Access Compliance Report Public Rights-of-Way (Curb Ramps)

Main Street: RED_HILL_AVE		Cross Street: GARLAND_AVE		Location:	W
ADA ID: RPRK220103152833	Ramp Type: Type 4 - Parallel	Initial Pass/Fail: Fail	Overall Compliance: No	Severity Score:	2
Codes/Mitigation Info/Possible Solution			Field Measurements/Component Compliance

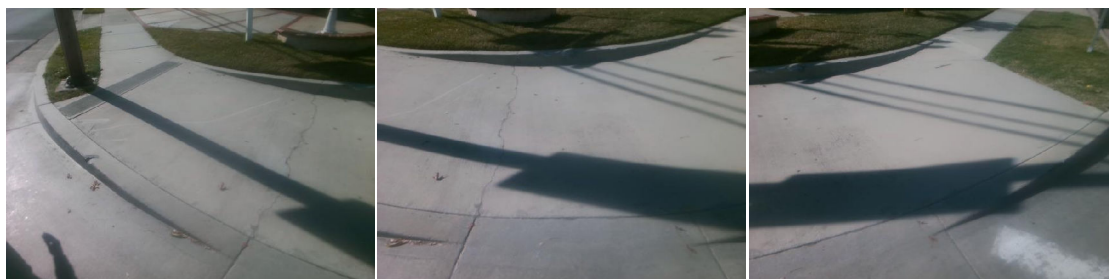
Compliance	Description	Data	Compliance	Description	Data
N/A	Ramp Length LT (in)	109	N/A	Ramp Length RT (in)	106
Yes	Ramp Width LT (in)	101	Yes	Ramp Width RT (in)	101
Yes	Ramp Run Slope LT (%)	4.5	Yes	Ramp Run Slope RT (%)	7.2
No	Ramp Cross Slope LT (%)	3.8	Yes	Ramp Cross Slope RT (%)	0.9
N/A	Landing Present	N/A	N/A	DWS Provided	N/A
N/A	Landing Length (in)	N/A	N/A	DWS Contrast	N/A
N/A	Landing Width (in)	N/A	N/A	DWS Length (in)	N/A
N/A	Landing Run Slope (%)	N/A	N/A	DWS Full Width	N/A
N/A	Landing Cross Slope (%)	N/A		DWS Offset Type	N/A
N/A	Landing Movement Obstructed?	N/A	N/A	DWS Offset Left (in)	N/A
	Landing Movement Type	N/A	N/A	DWS Offset Right (in)	N/A
N/A	Landing Shared	N/A			
N/A	Clear Space	Yes			
N/A	Clear Space To Crosswalk (in)	N/A			
N/A	Marked Crosswalk 1	No	N/A	Marked Crosswalk 2	No
	Crossing 1 Direction	SE		Crossing 2 Direction	NE
	Marked Crosswalk 1 Width (in)	N/A		Marked Crosswalk 2 Width (in)	N/A

Remove & Replace Curb Ramp With Two New Directional Ramps or Equivalent.
